October 8, 2019

**BOARD OF COUNTY COMMISSIONERS
ORANGE COUNTY, FLORIDA
ADDENDUM NO. 1/IFB Y20-718-TA**

**SOUTHWEST MARRIOTT PS#3597
ODOR CONTROL SYSTEM**

SITE PLAN - ODOR CONTROL SYSTEM

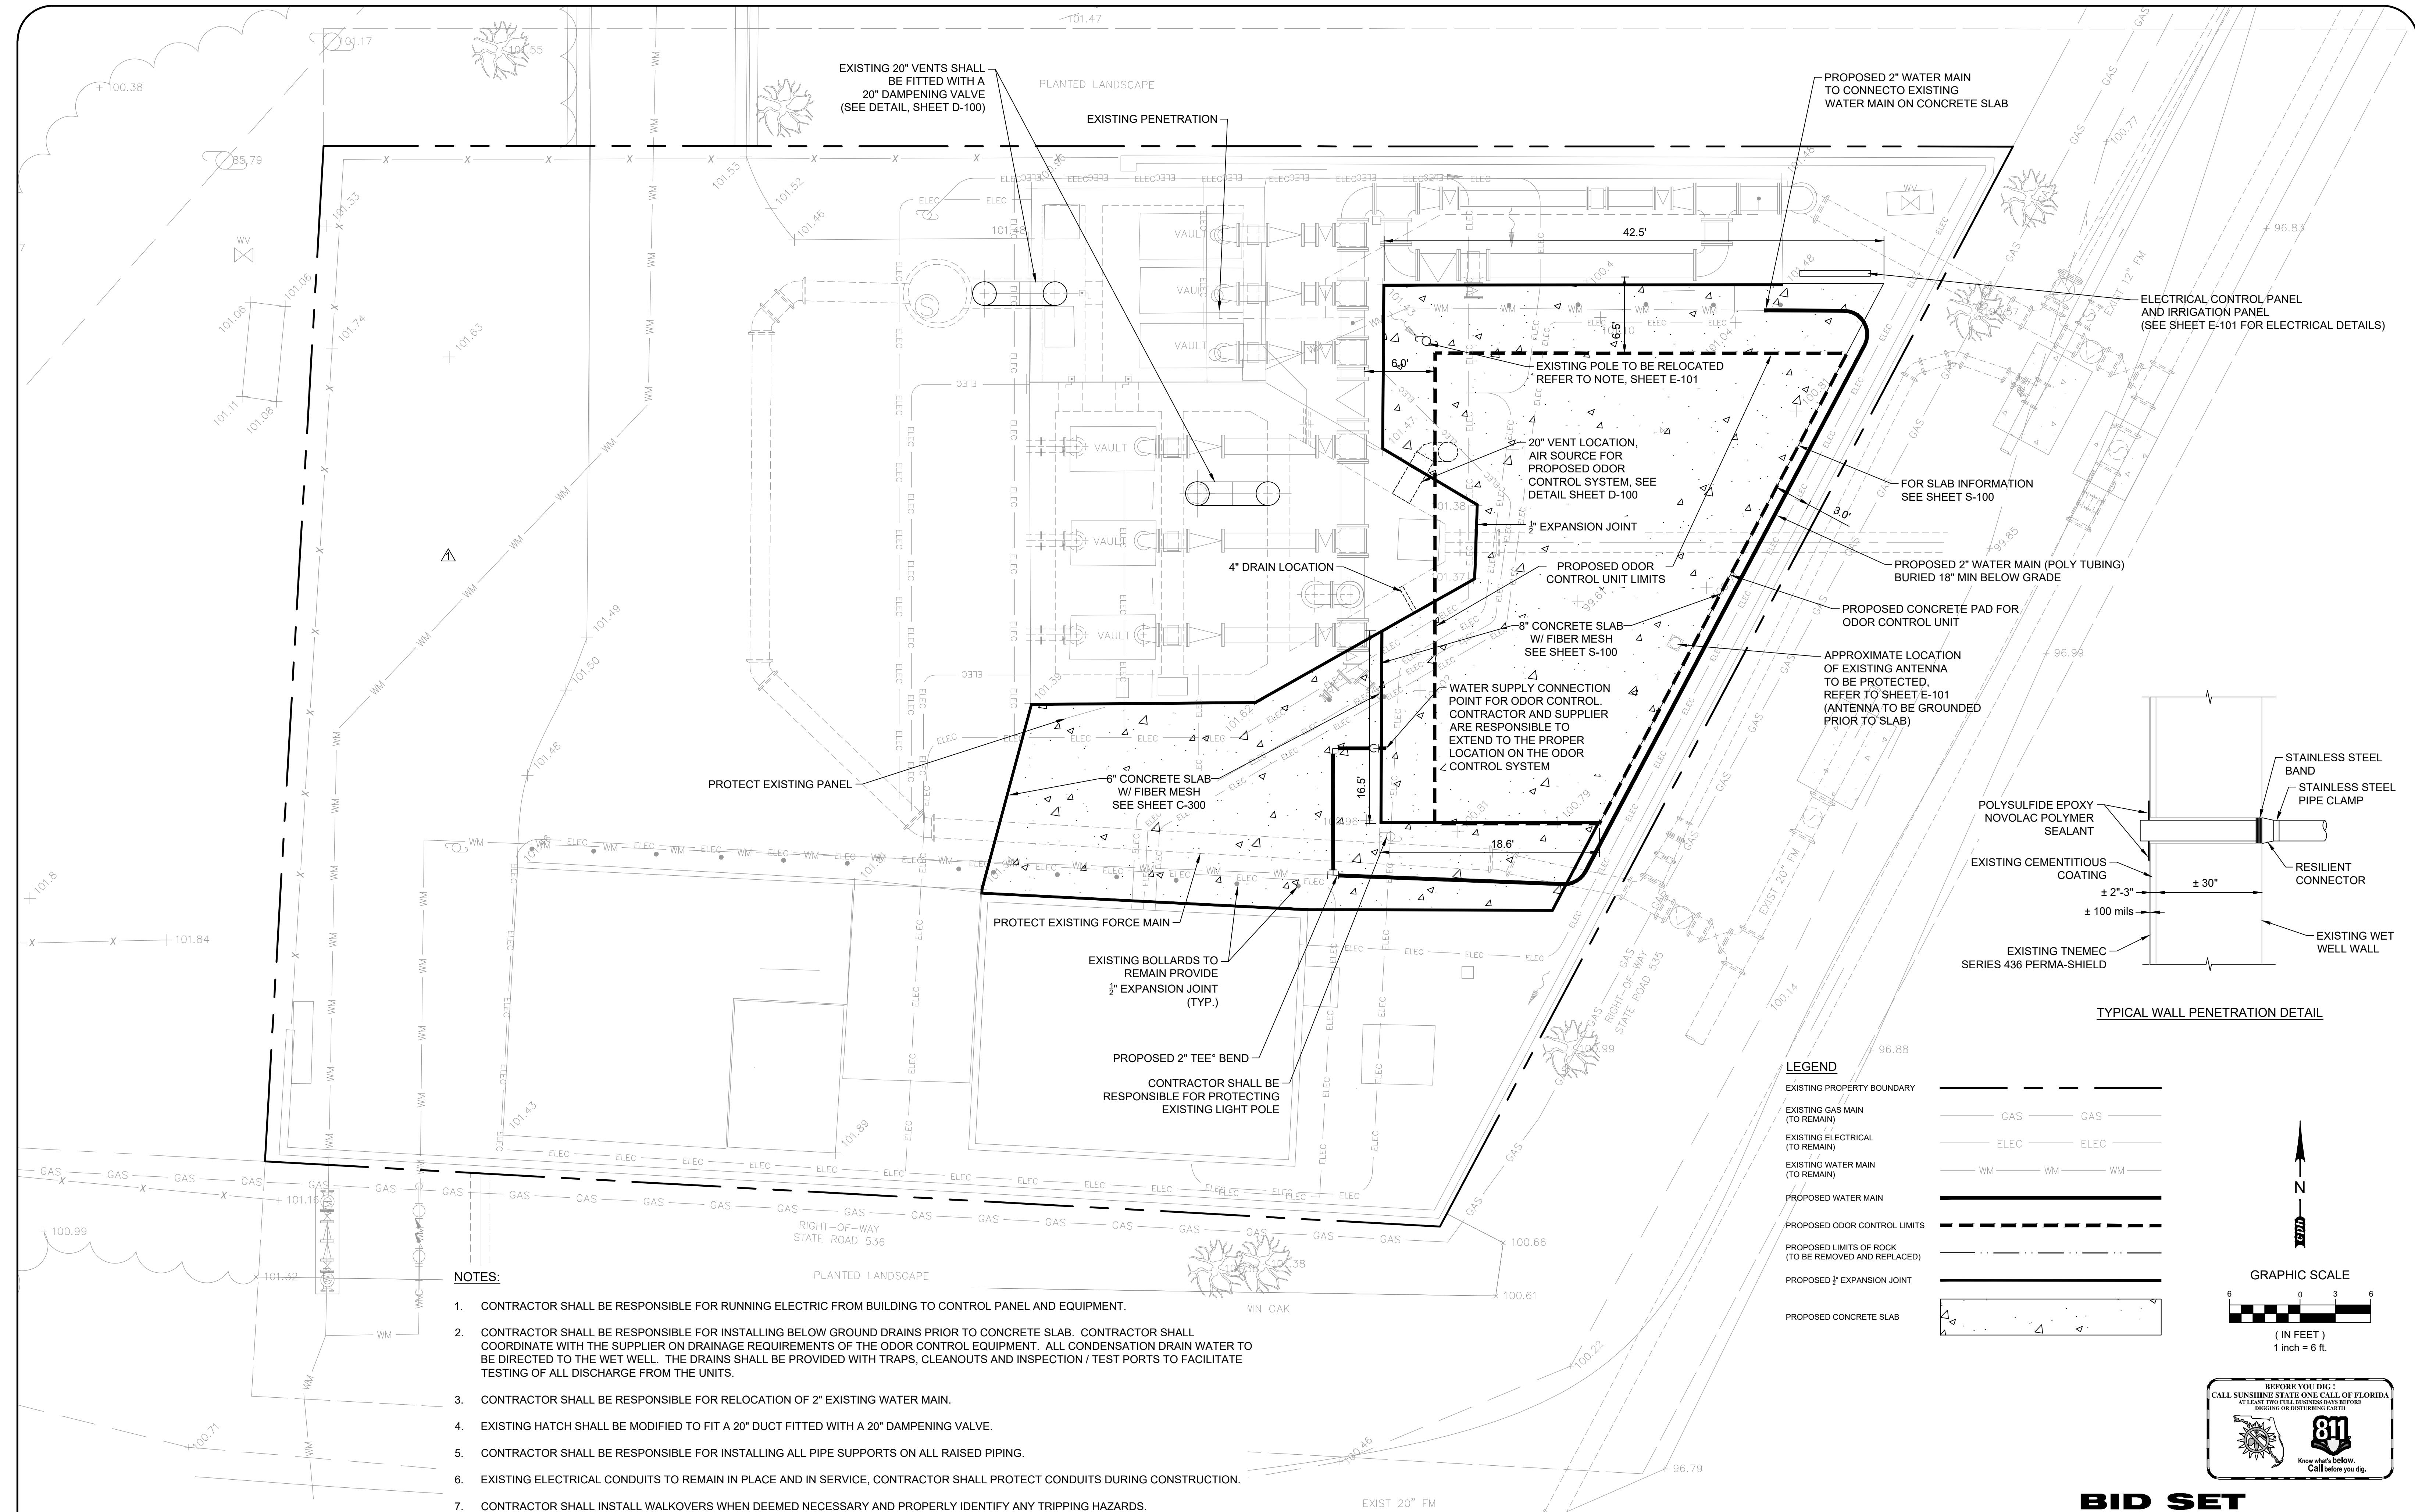
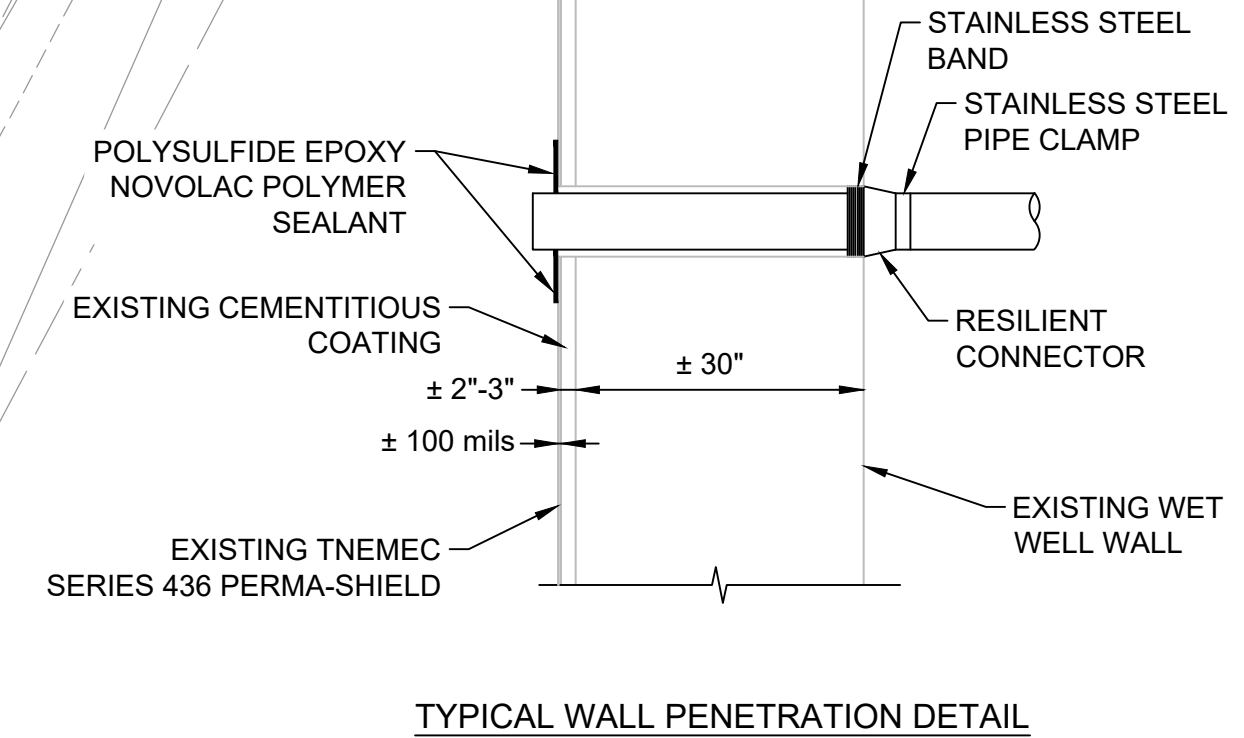
Question No. 1: On sheet 8 of 13 you show a wall penetration detail. How thick is the wall?

Question No. 2: On sheet 8 of 13 you show a wall penetration detail. Is there a liner system? If so, which system?

1. ~~Delete G-200~~ and replace with Revised Sheet C-200, Concrete work on the west side of the property removed.
2. Delete C-300 and replace with Revised Sheet C-300, Concrete work on the west side of the property removed.

Response No.1: Wall thickness of 30-inches is referenced on revised sheet C-200 on the Typical Wall Penetration Detail.

Response No.2: Yes, the existing lining system is Tnemec Series 436 Perma-Shield.
